SUBJECT: Transmittal of the Addendum for the Response to Comments for the Draft Sampling and Analysis Plan (SAP) for Operable Unit (OU) 3-07 at the Idaho Chemical Processing Plant (ICPP) Waste Area Group 3 (WAG 3) - RPO-091-92

**EPA REGION X AND STATE OF IDAHO
COMMENTS ON
WAG 3 OPERABLE UNIT-07**

REVIEW COMMENTS
IDAHO CHEMICAL PROCESSING PLANT
SAMPLING AND ANALYSIS PLAN
FOR OPERABLE UNIT 3-07
TANK FARM AREA

ADDENDUM
TO DRAFT SAMPLING AND ANALYSIS PLAN
OPERABLE UNIT 3-07, TANK FARM

Figure 2-5. Surface Release Sites Conceptual Site Model.

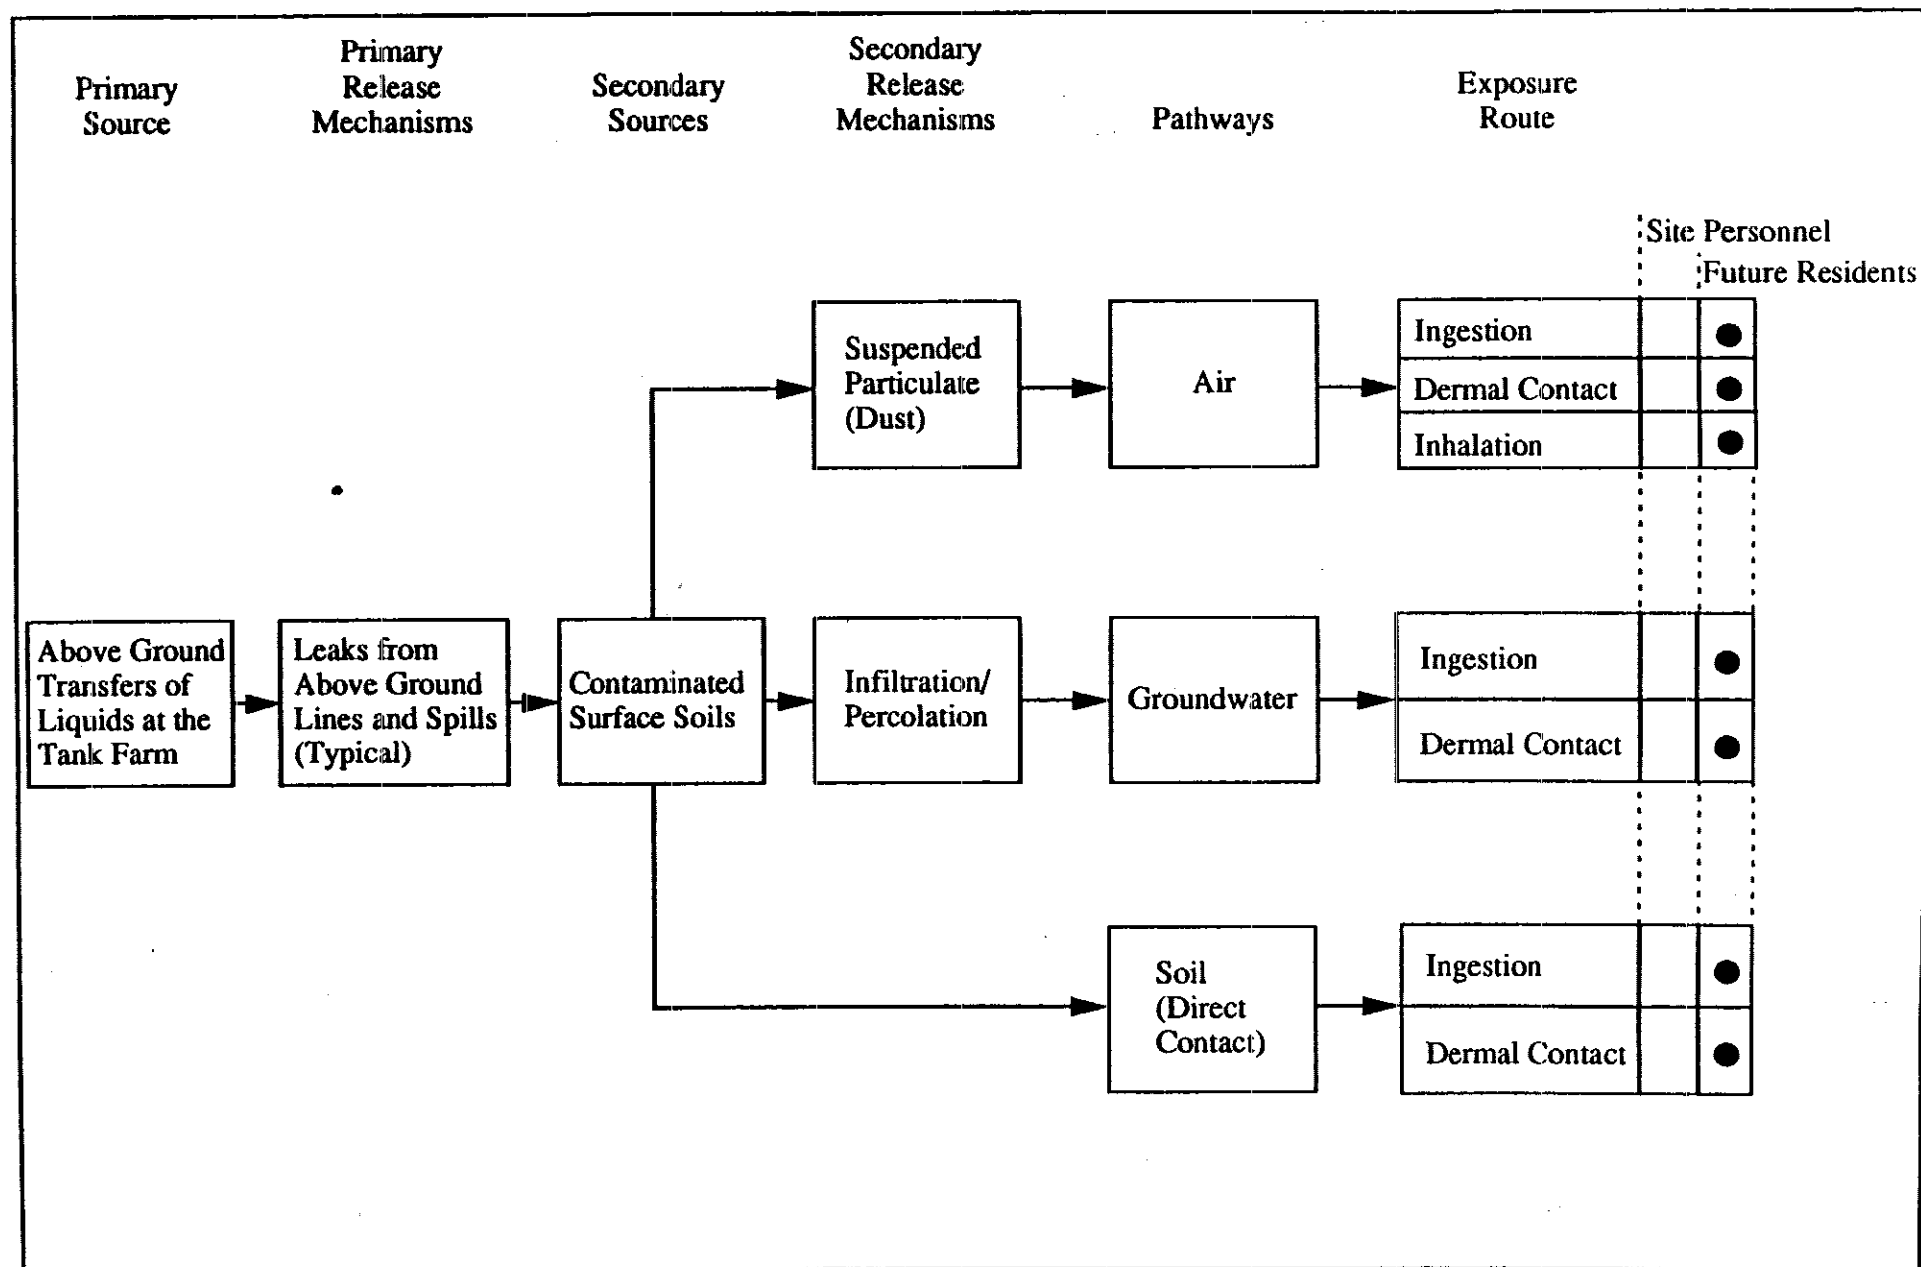
- A. Reference to "original releases which predated 1976" and Figure 2-5 are inconsistent with the characterization of CPP-26 as a one-time air release event.

- C. Revise Figure 2-5 to include both generator and artifact as parameters.

6. In future documents, attempts will be made to streamline presentation of the data and information presented.
- 7ABC. A revised CSM is included in attachment A to this addendum to address these comments.

Figure 2-7. Subsurface Release Sites Conceptual Site Model.

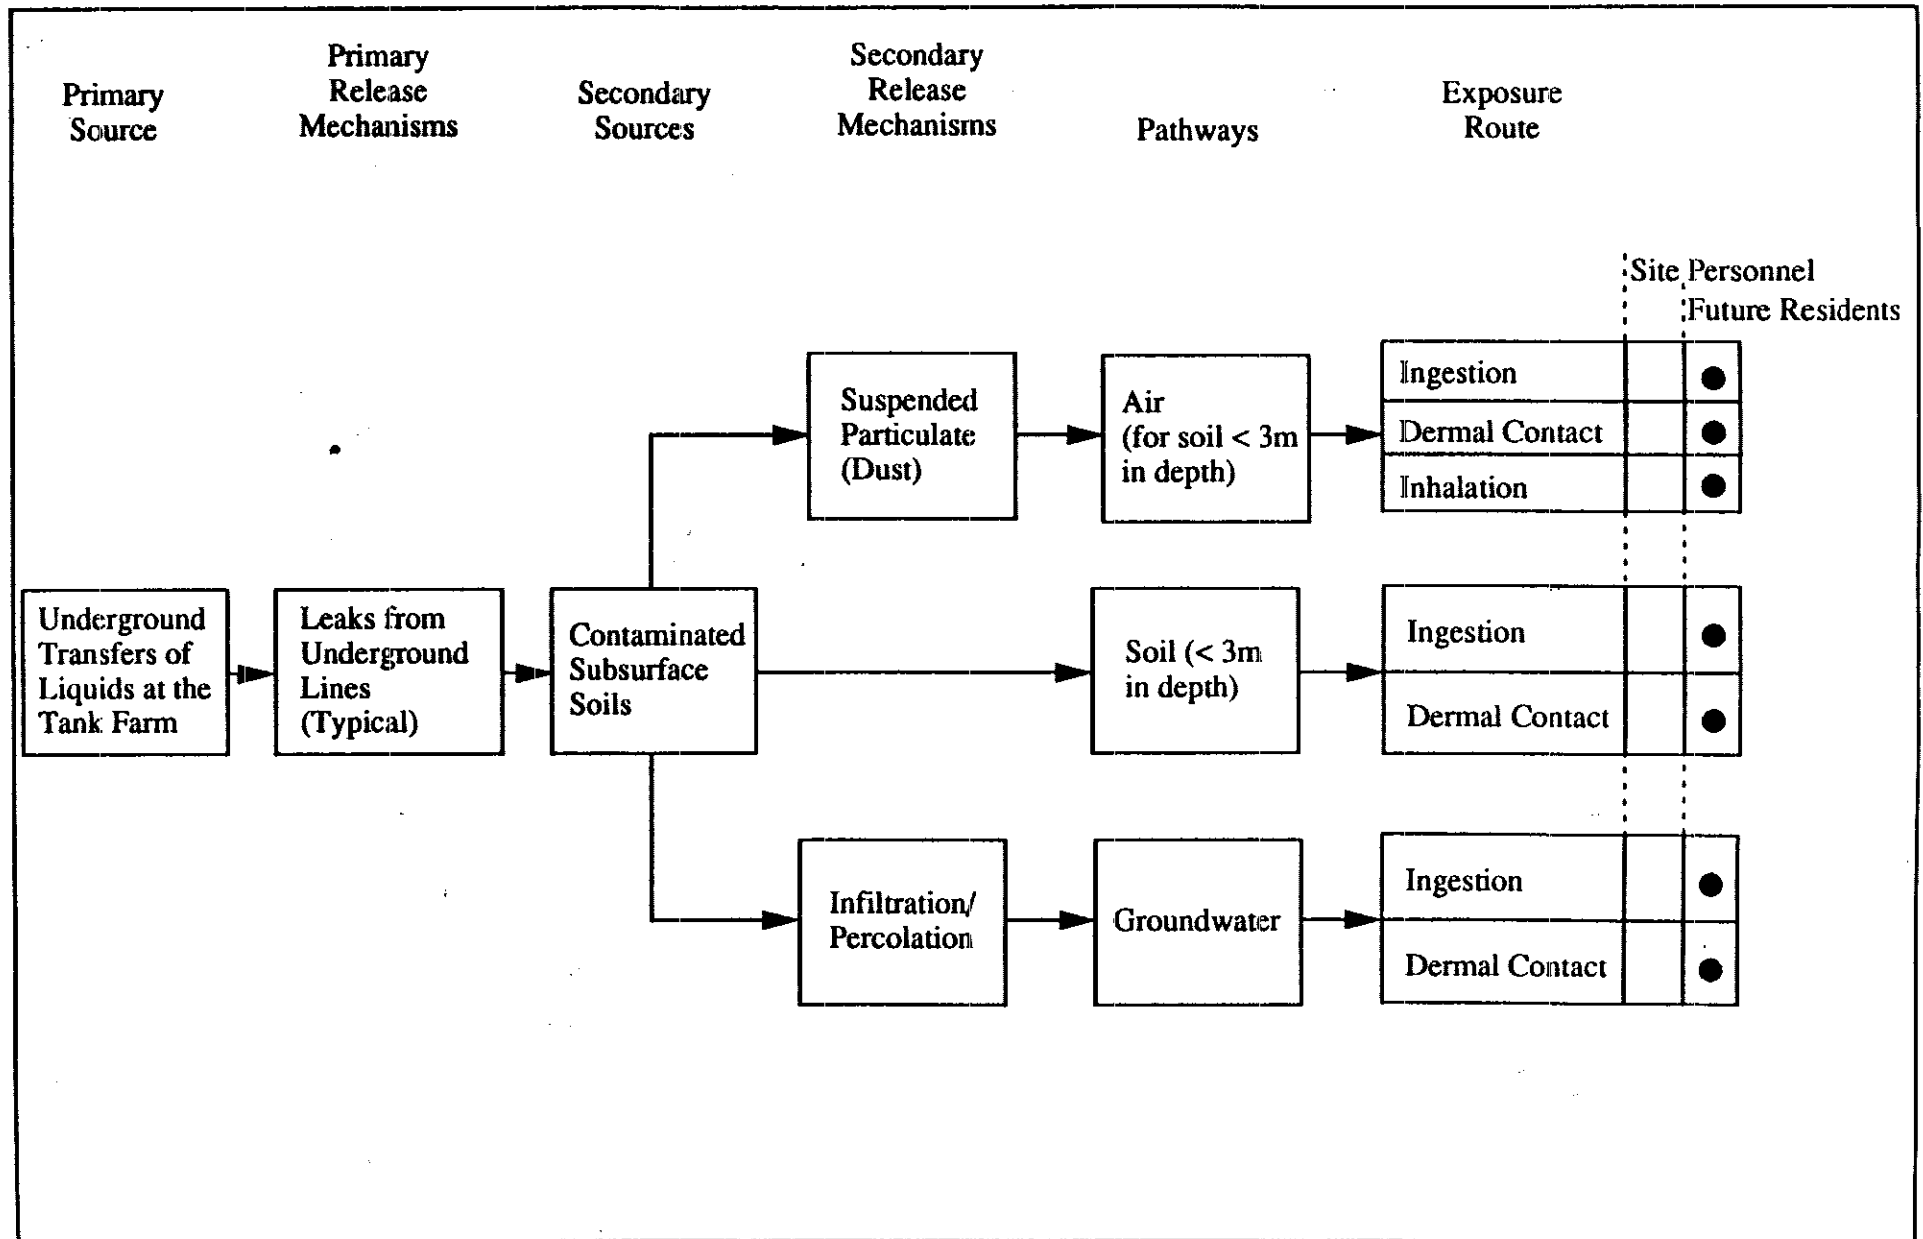
- B. The speculative effect of institutional controls to minimize occupational risk should be deleted from both the text and Figure 2-7.

- 8AB. As a result of additional guidance provided for Track 2 Risk Evaluations, the CSM has been revised and is included as attachment A to this addendum. The scenarios are presented in the discussion.

37. Refer to attachment B. A revised CSM has been prepared based upon new exposure scenario's.

Figure 2-8. Perched Water Contamination Conceptual Site Model.

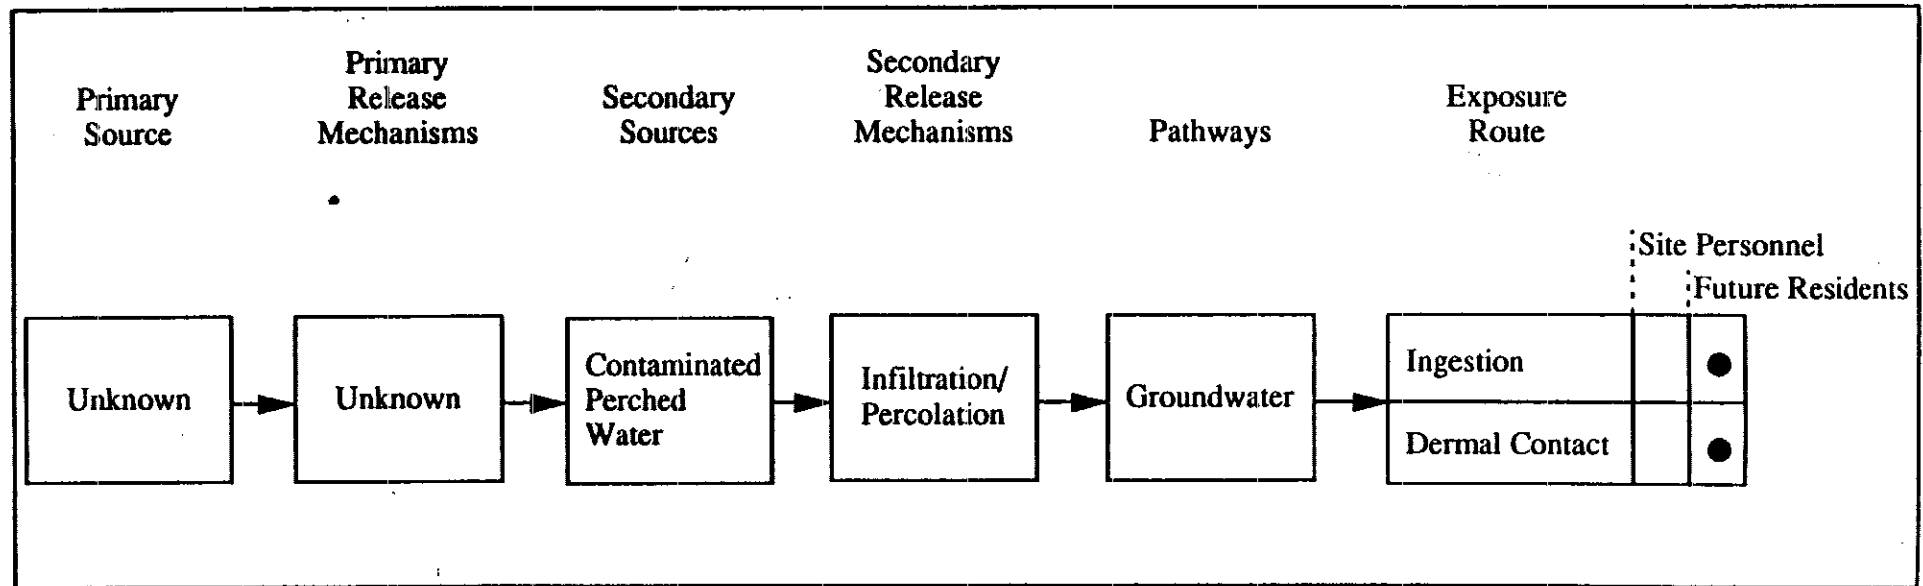
(This comment also applies to Figures 2.7 and 2.8.)

Figure 2-6

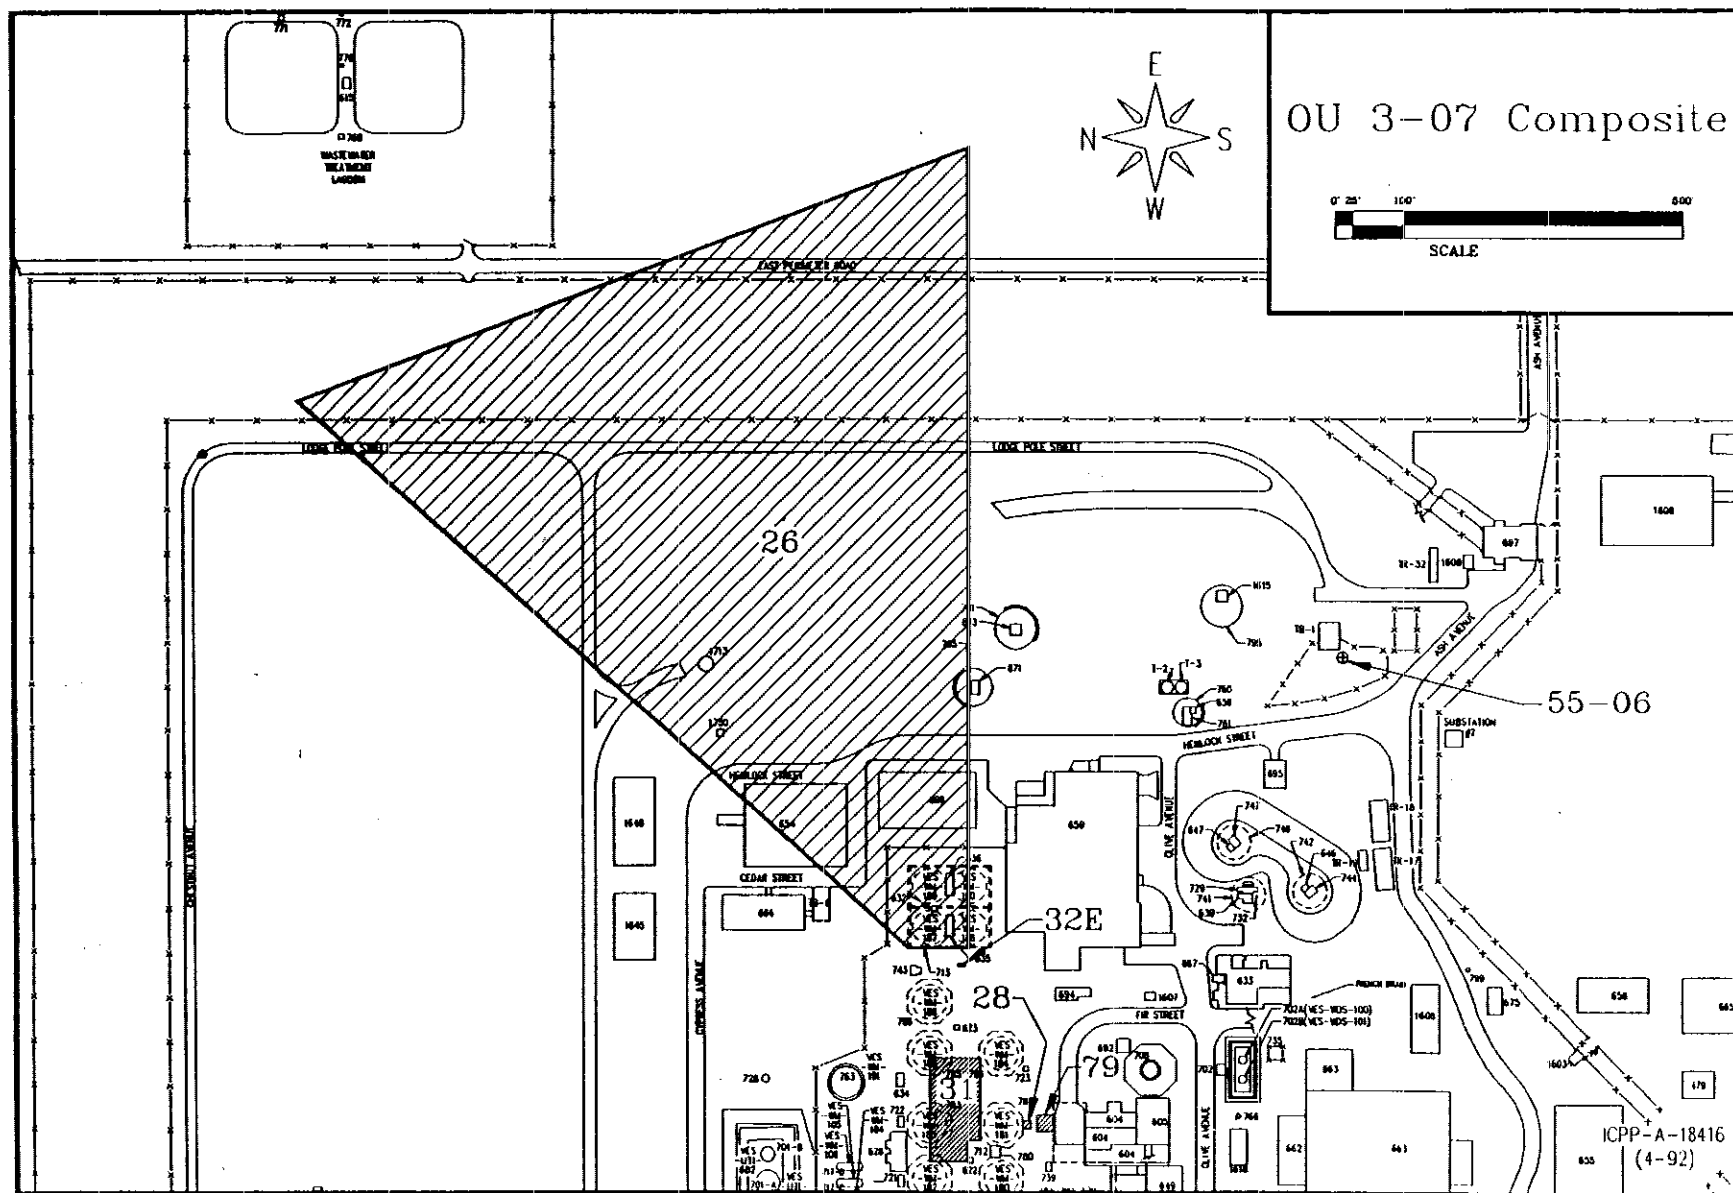
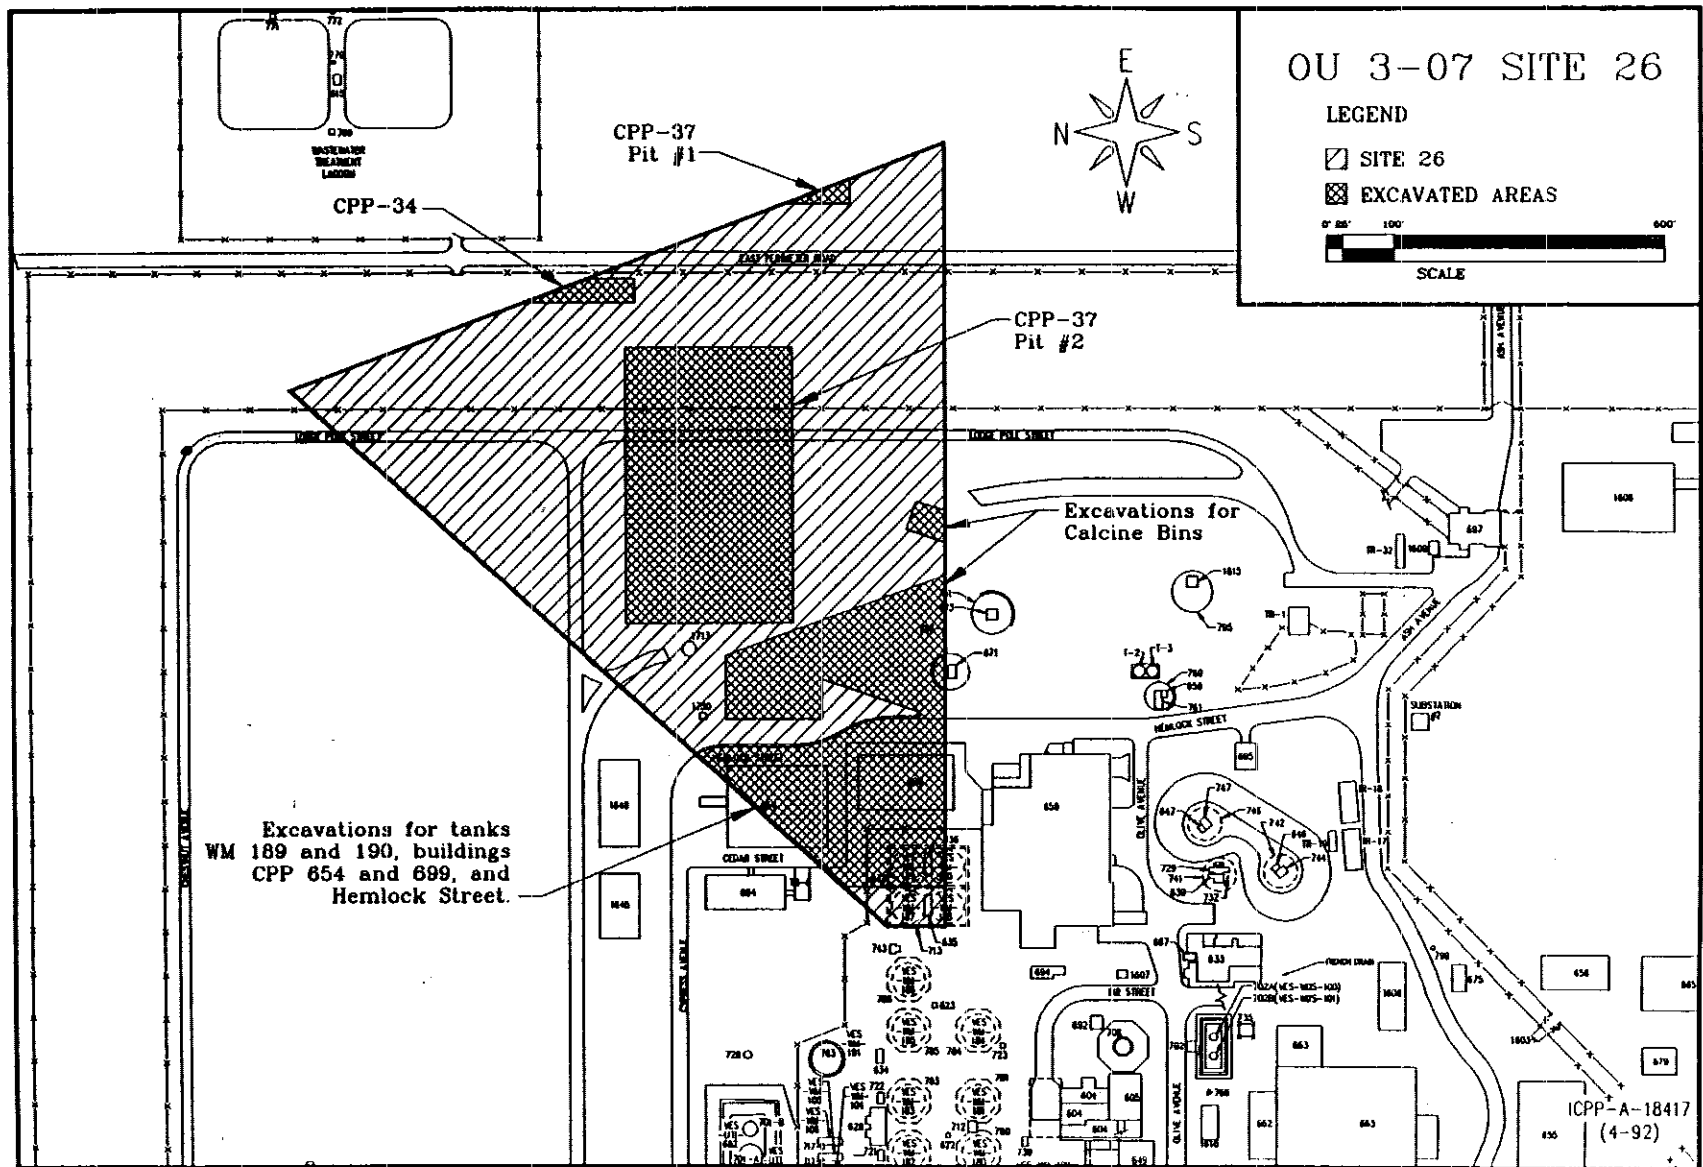
Figure 2-6 should clearly delineate the sites mentioned.

Please note tanks WM 189 and 190, along with buildings CPP 699 and 654 on figure 2-6 more clearly?

32. A revised figure is included in attachment A.
